City of Carlisle, Iowa
Planning and Zoning Commission
Regular Meeting
July 18, 2022

RE: Ridgewood Valley Plat 1 – Construction Drawing Review
PROJECT #7023.057

RE: Ridgewood Valley Plat 1 – Final Plat Review
PROJECT #7023.058

INTERSECTION & MISCELLANEOUS DETAILS

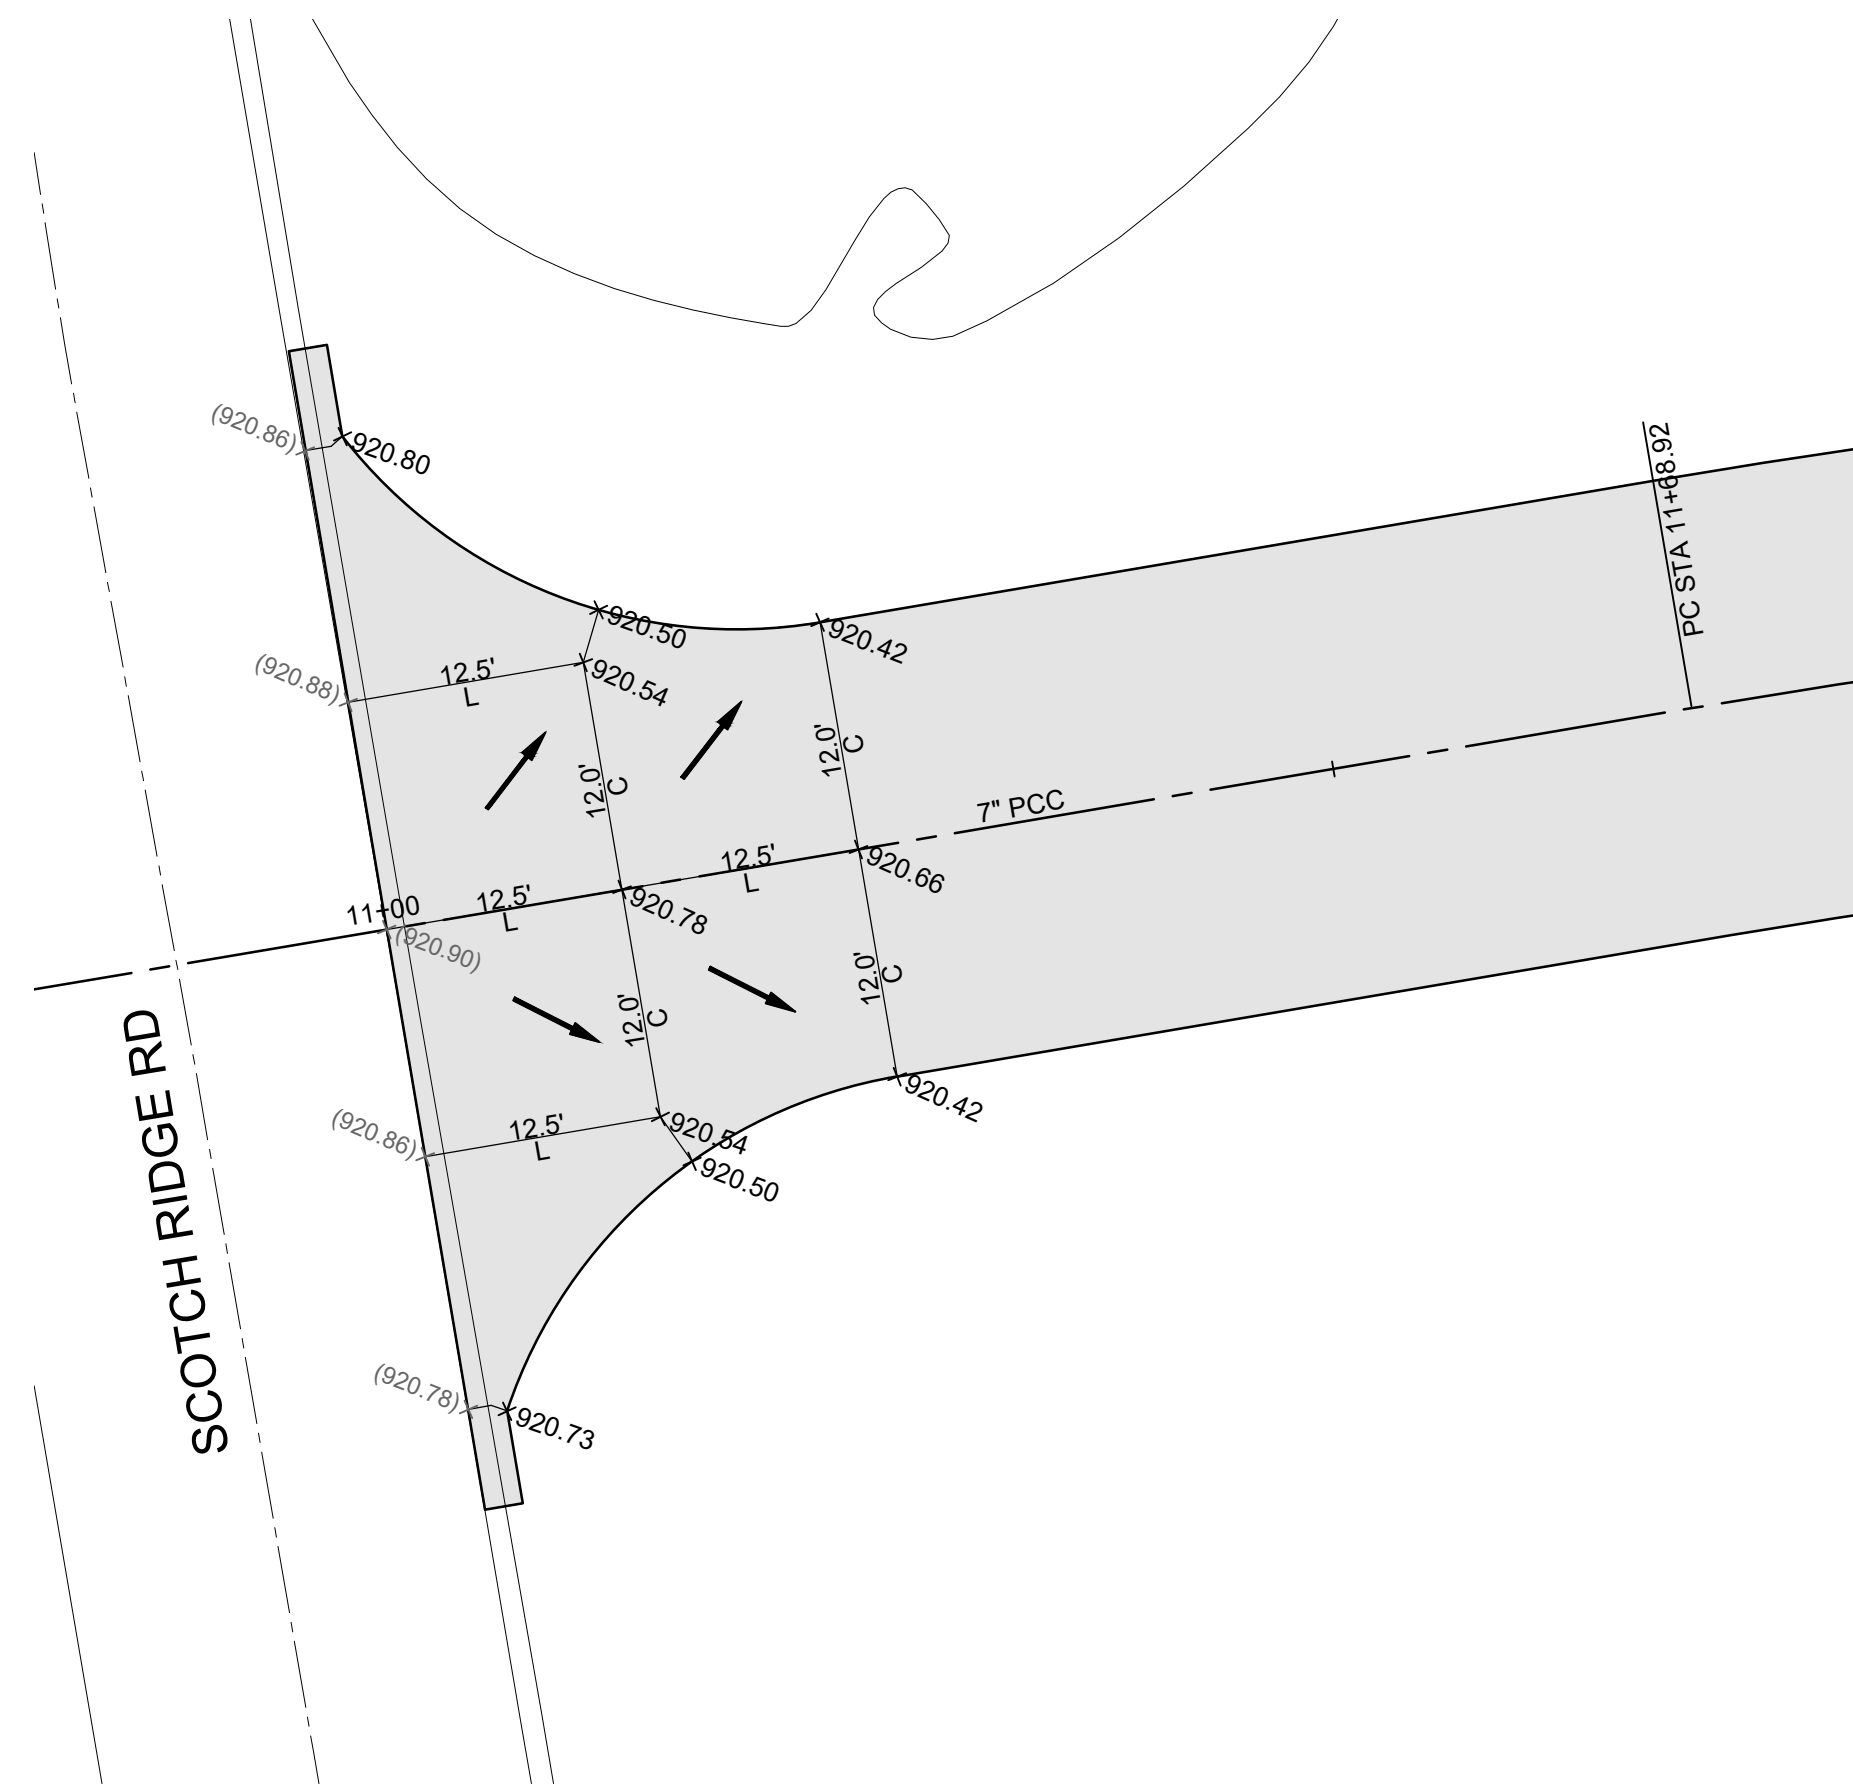
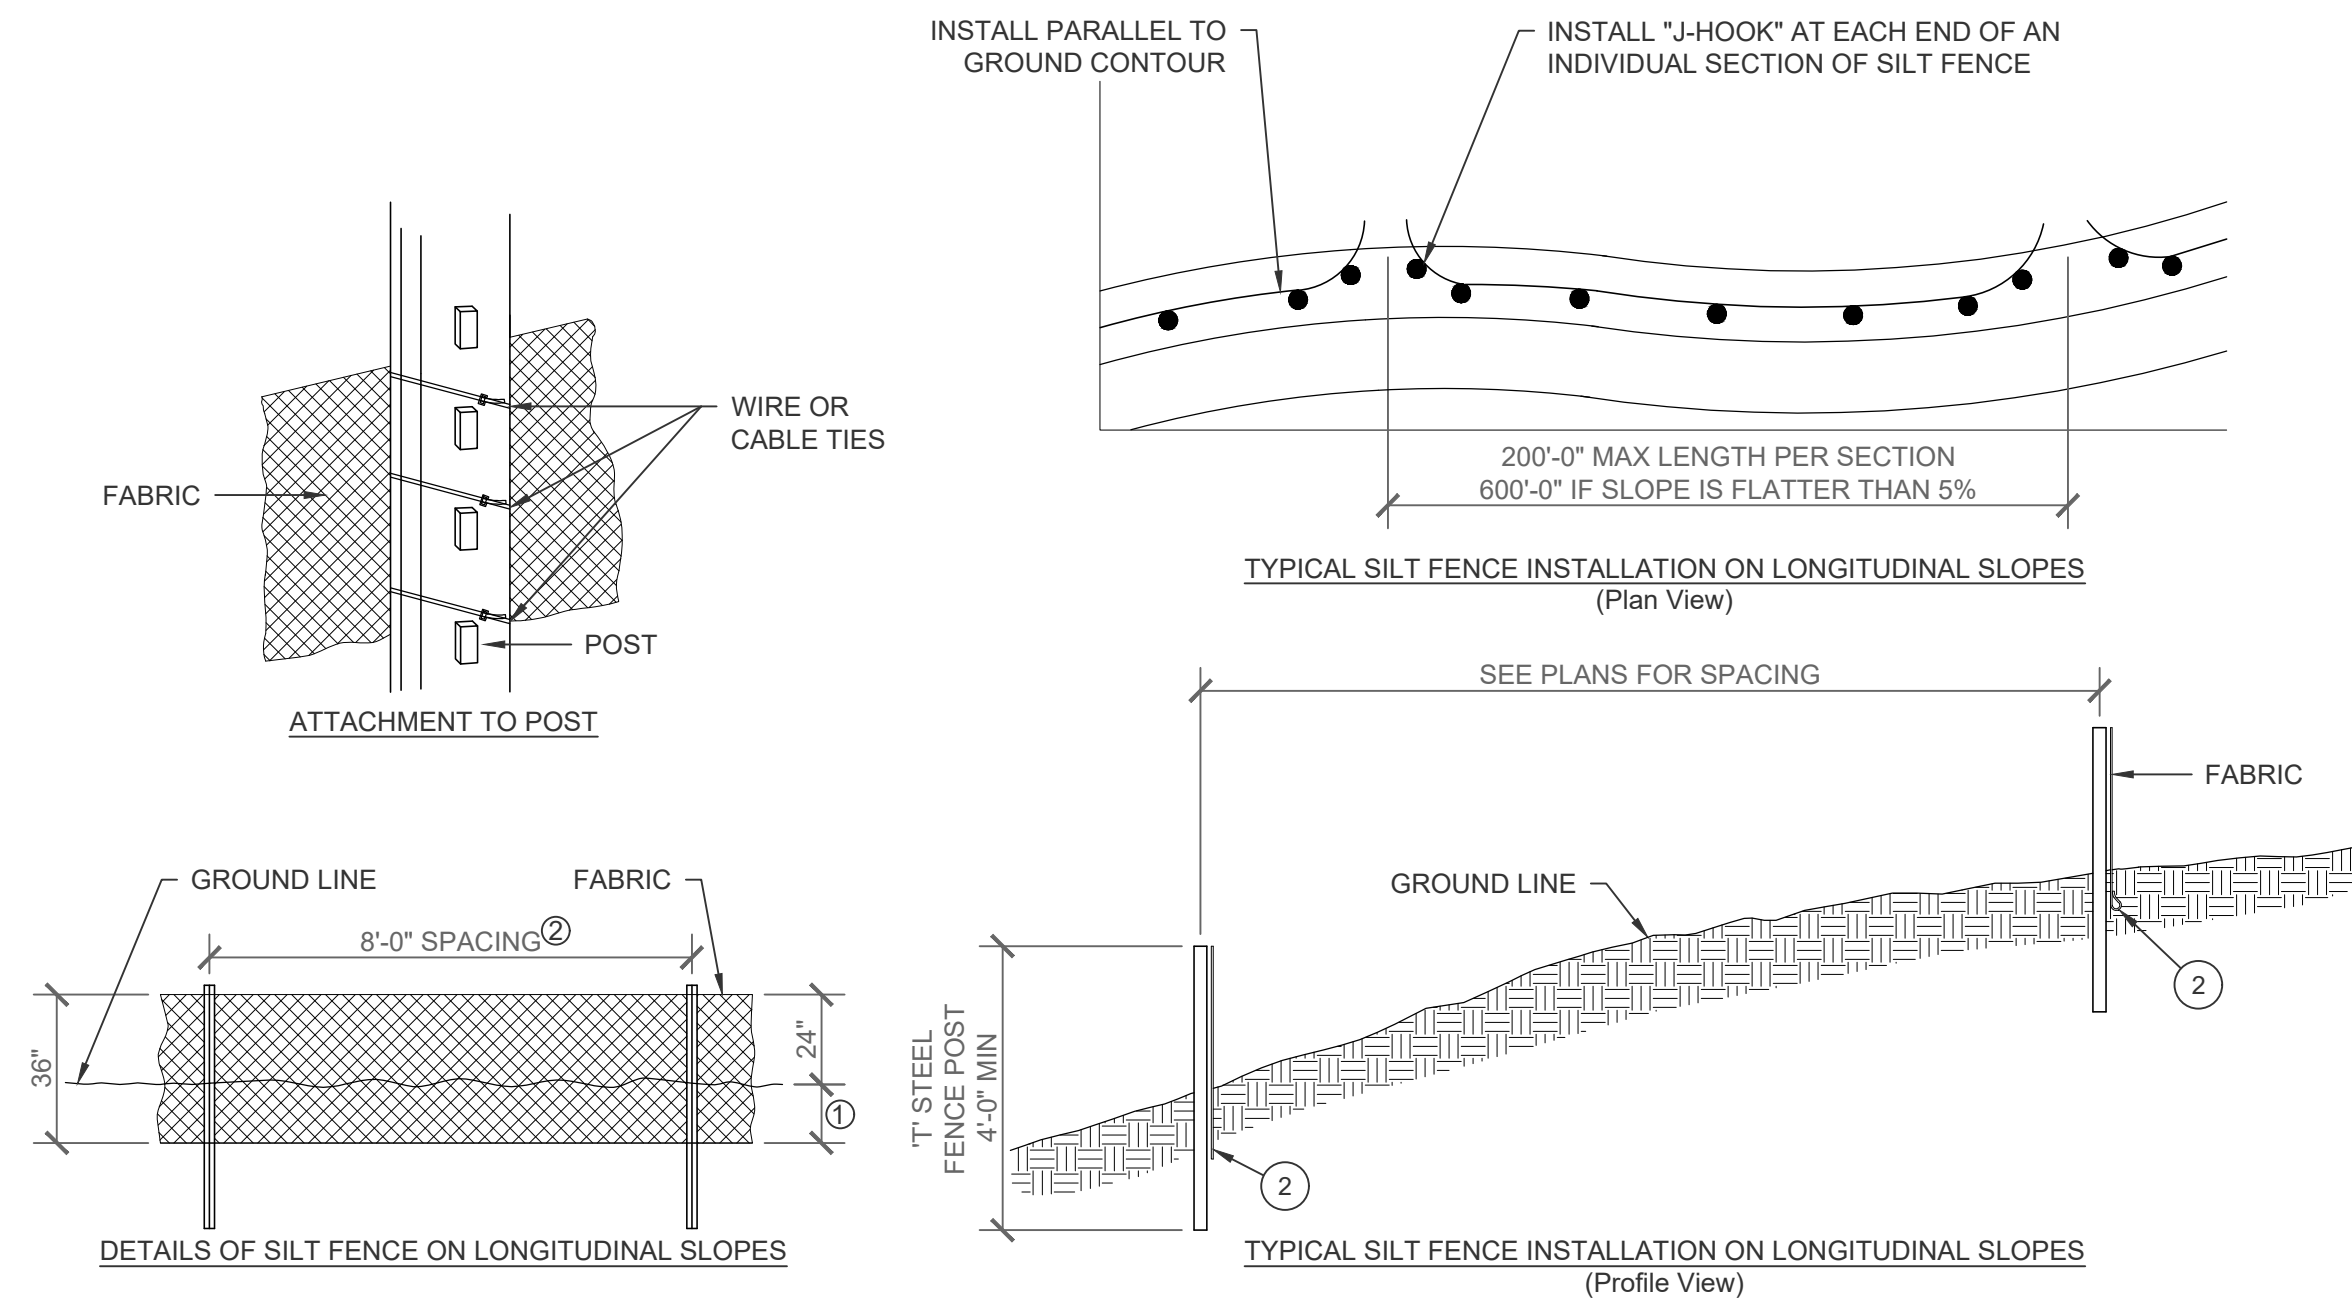
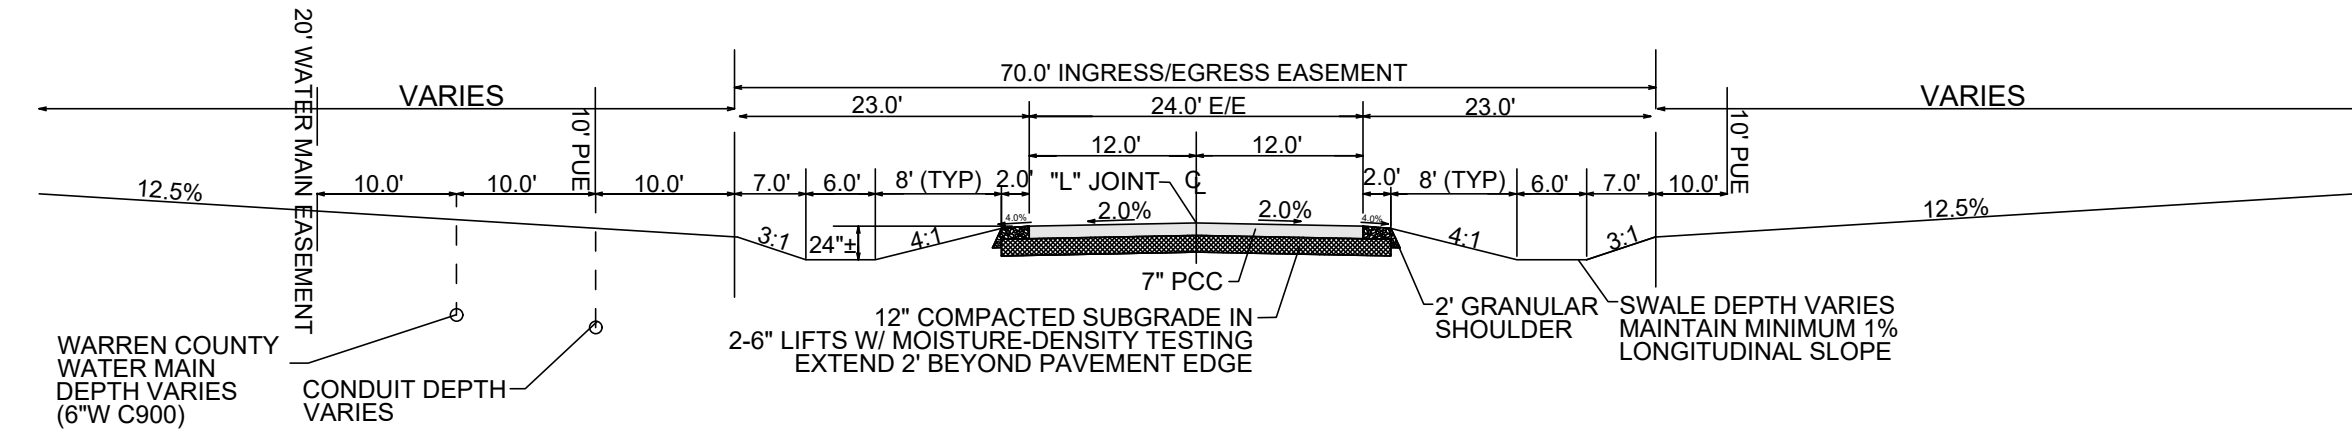
19. Please label the pavement removal along Scotch Ridge Road. What is the double line along the south side of said roadway representing?
20. Please label the intersection return radii.
